FAQ Number 07-0036

FAQ Title Incorporation of Pilot Plant Lessons Learned - Table B-1

Plant: Harris

Date: December 20, 2007

Figure 4-2 - Fundamental Program and Design Elements Transition Process (Simplified)

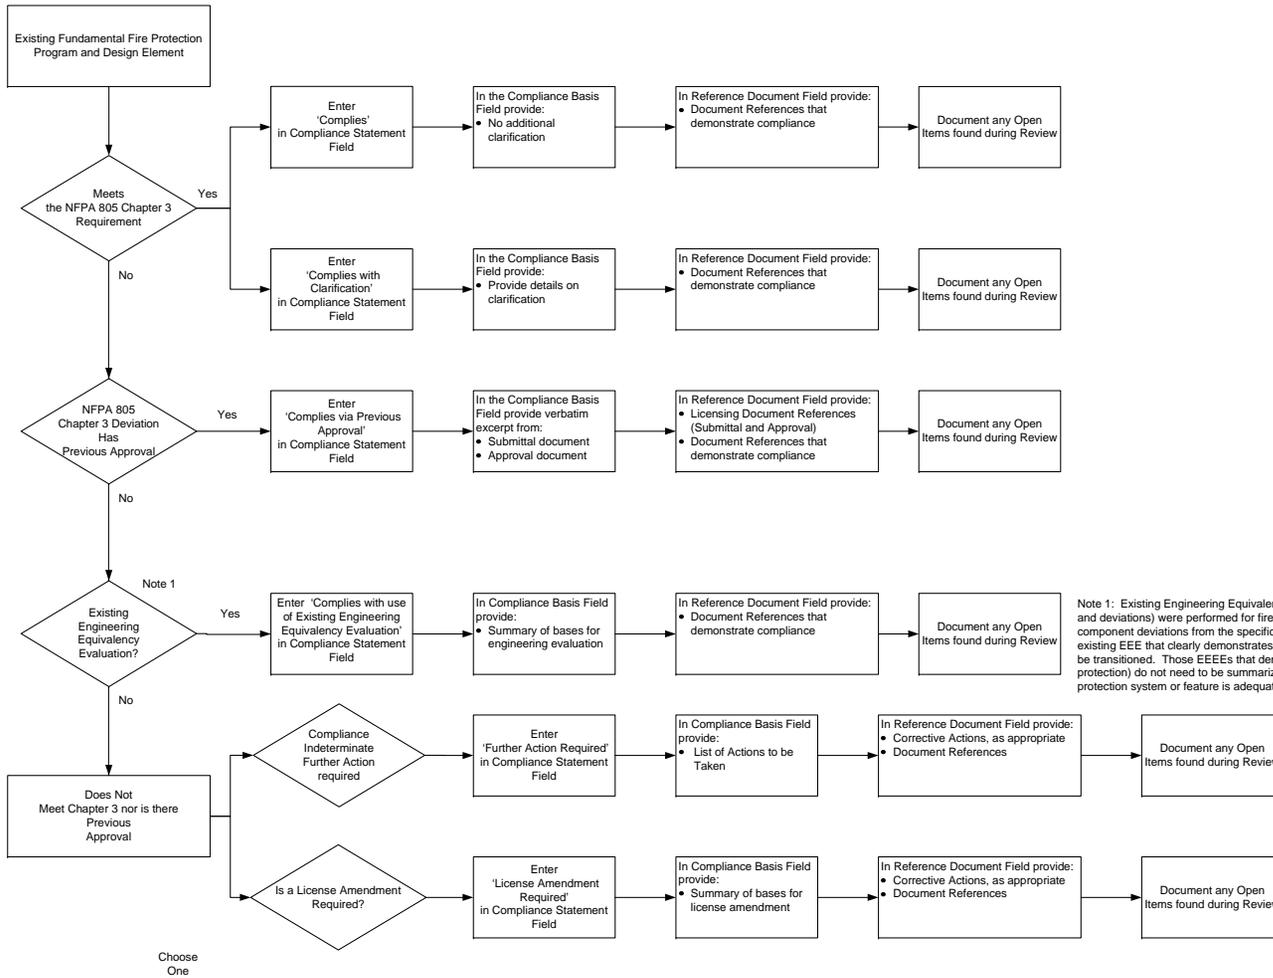
Guidance needs to be provided to document the specific compliance categories assigned and methodologies used during the Chapter 3 review, and to update Figure 4-2 to reflect the process used by the pilot plants.

A simplified flowchart of the fundamental program and design elements transition review is provided as Figure 4-2.
